ADDENDUM NO. 1
to the Project Manual for the

HUMBOLDT BAY MUNICIPAL WATER DISTRICT
TRF GENERATOR PROJECT

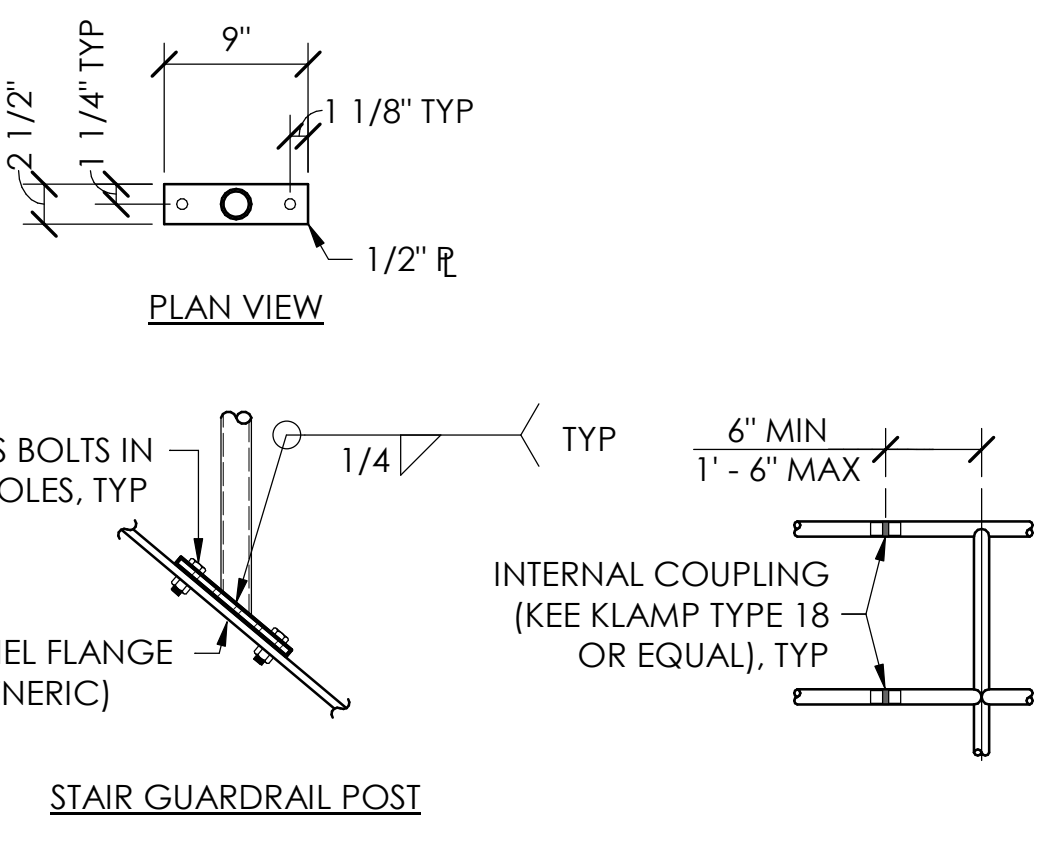
REVISIONS		
NO	DATE	DESCRIPTION
1	2/14/25	ADDENDUM NO. 1

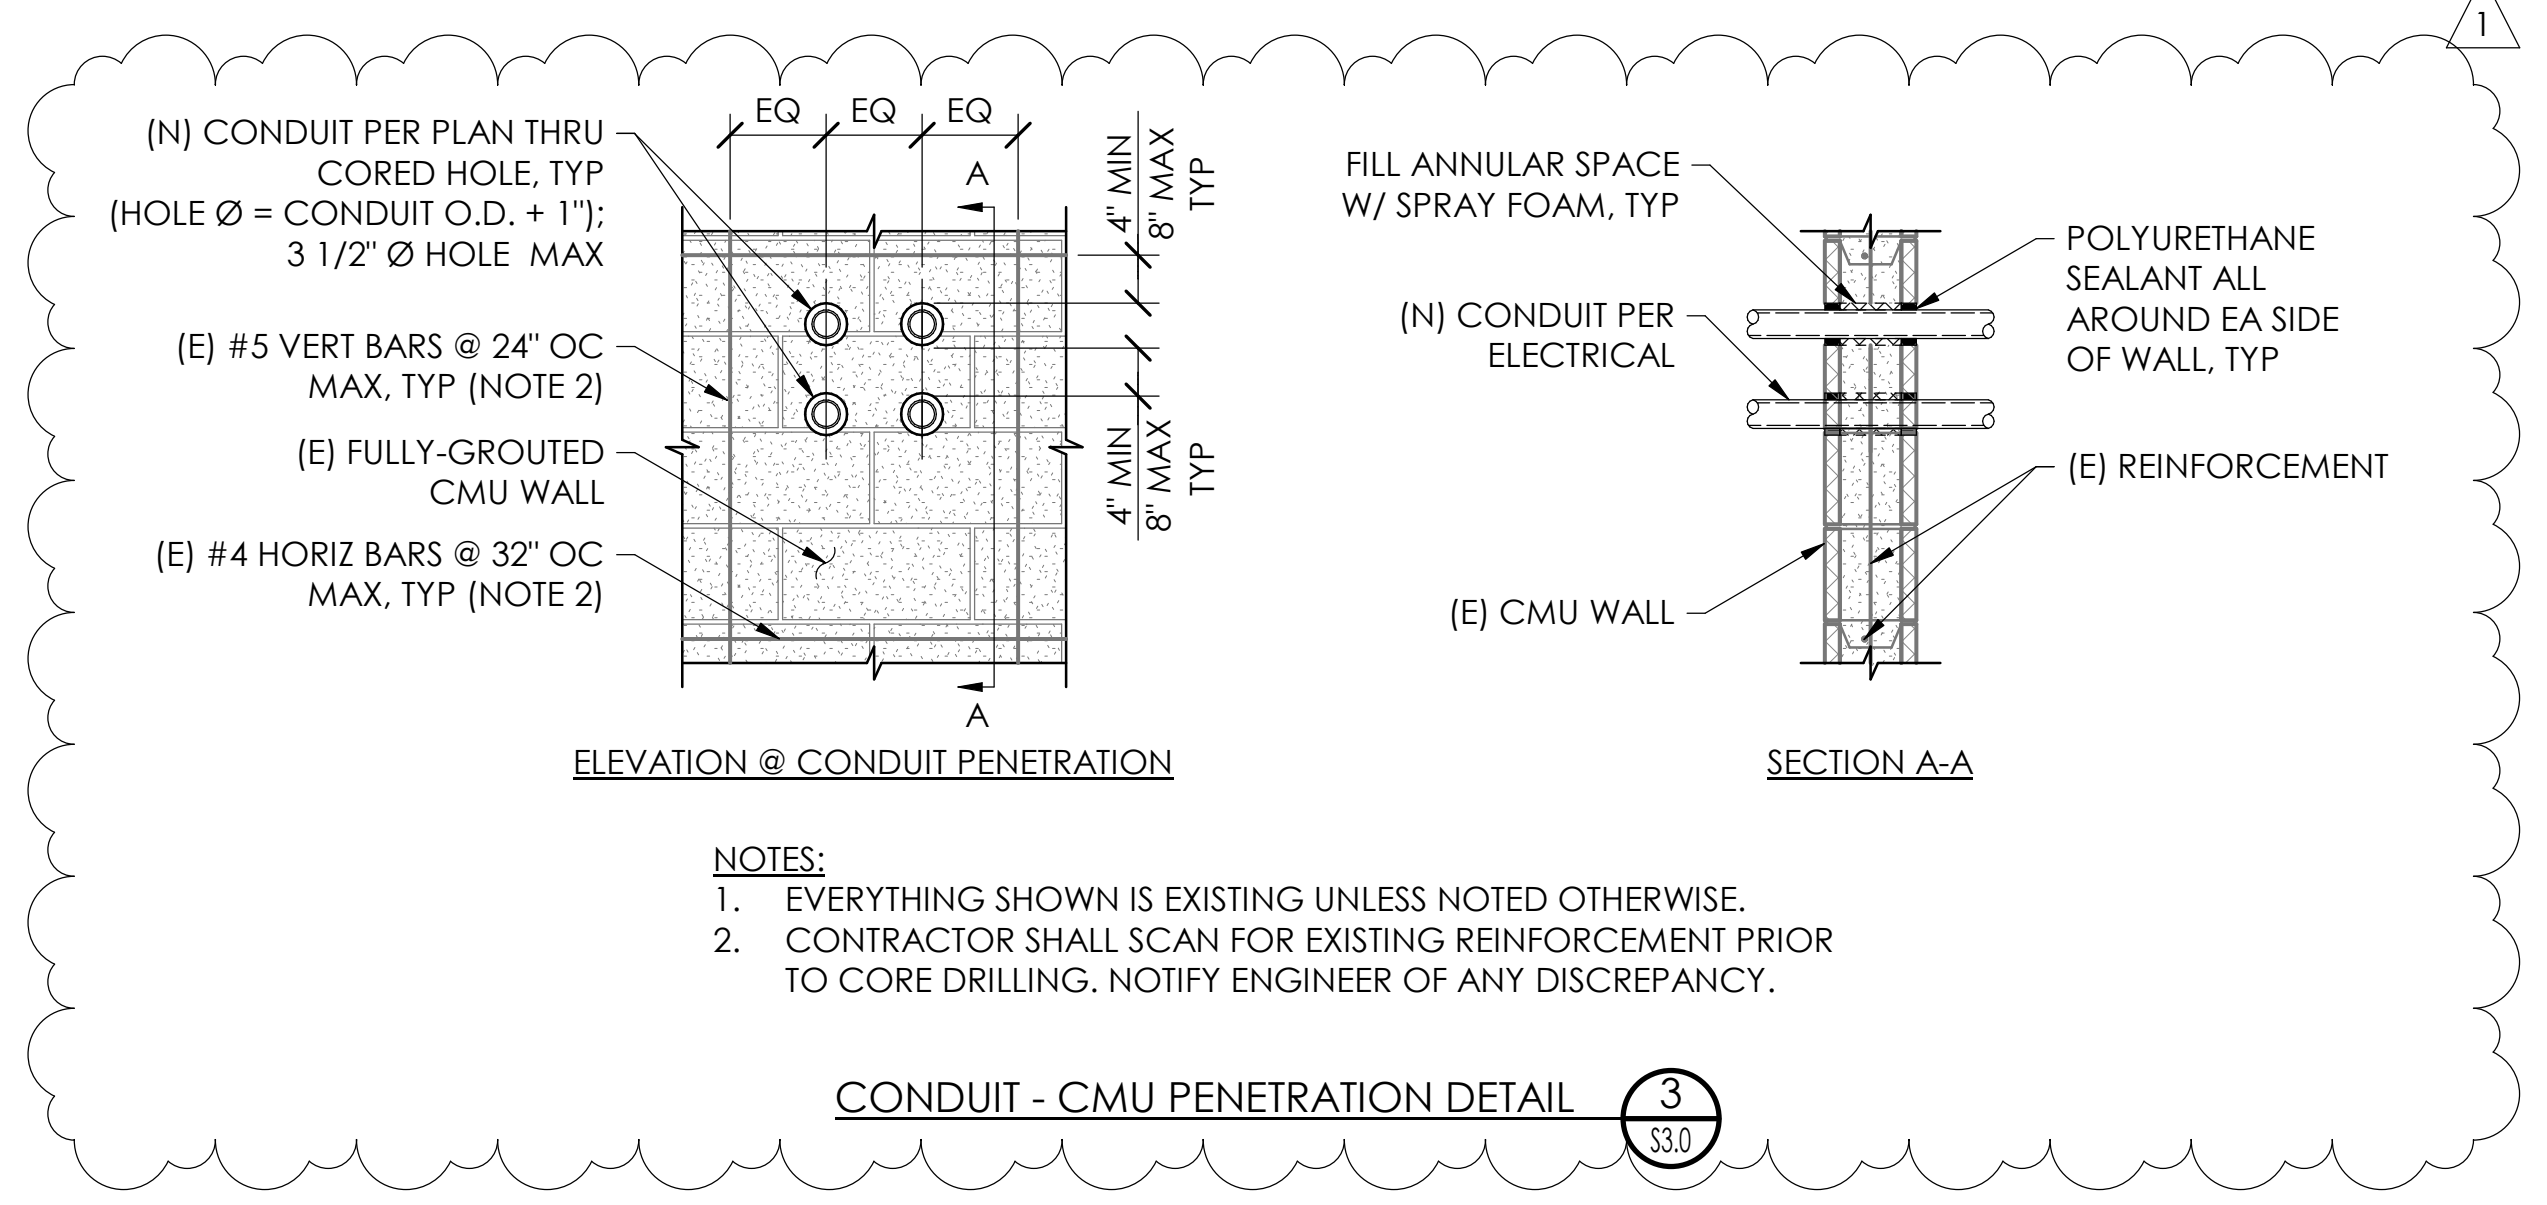
REVISIONS		
NO	DATE	DESCRIPTION
1	2/14/25	ADDENDUM NO. 1
